PIC16C74A Rev. A Silicon Errata Sheet

The PIC16C74A (Rev. A) parts you have received conform functionally to the Device Data Sheet (DS30390E), except for the anomalies described below.

FIGURE 1: SCK PULSE VARIATION USING TIMER2/2

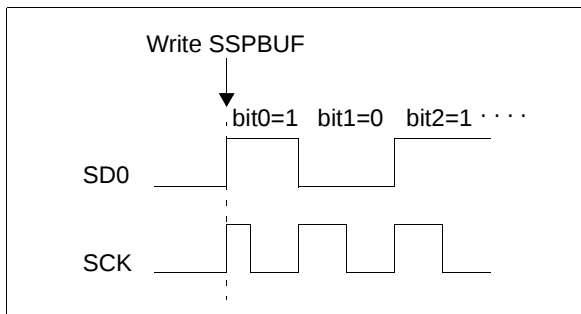
When the SPI is using Timer2/2 as the clock source, a shorter than expected SCK pulse may occur on the first bit of the transmitted/received data (Figure 1).

To avoid producing the short pulse, turn off Timer2 and clear the TMR2 register, load the SSPBUF with the data to transmit, and then turn Timer2 back on. Refer to Example 1 for sample code.

FIGURE 1: WRITES TO TIMER1 (EXTERNAL CLOCK/OSCILLATOR MODE)

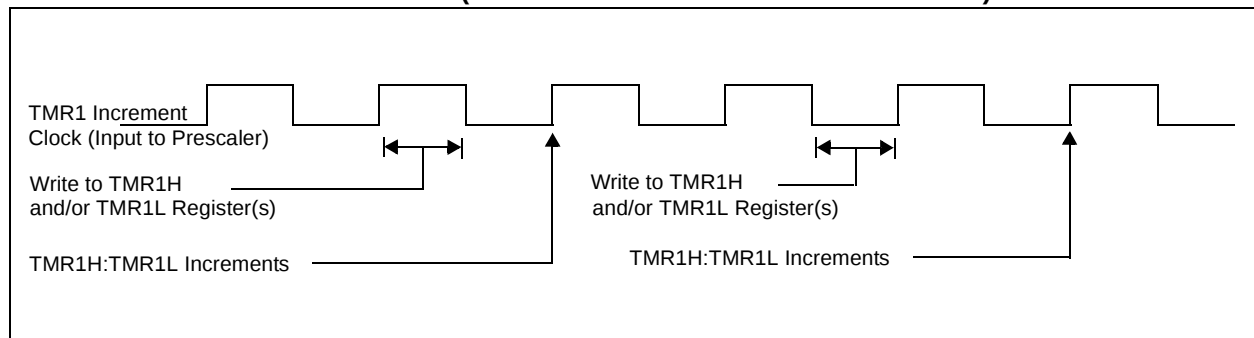
The operation of Timer1 needs some clarification when the timer registers are written when the TMR1ON bit is set.

The internal clock signal that is the input to the TMR1 prescaler affects the incrementing of Timer1 (TMR1H:TMR1L registers and the Timer1 prescaler). When the Timer1 registers are NOT written, the Timer1 will increment on the rising edge of the TMR1 increment clock.

When the TMR1H and/or TMR1L registers are written while this clock is high, TMR1 will increment on the next rising edge of this clock.

When the TMR1H and/or TMR1L registers are written while this clock is low, TMR1 will not increment on the next rising edge of this clock, but must first have a falling clock and the rising clock, for TMR1 to increment.

Figure 1 shows the two cases of writes to the TMR1H and/or TMR1L registers. Due to the V_{IH} and V_{IL} thresholds on the oscillator/clock pins, external Timer1 oscillator components, and external clock frequency, the Timer1 increment clock may not be of a 50% duty cycle.

The TMR1 increment clock is out of phase of the T1OSO/T1CKI pin by a small propagation delay.
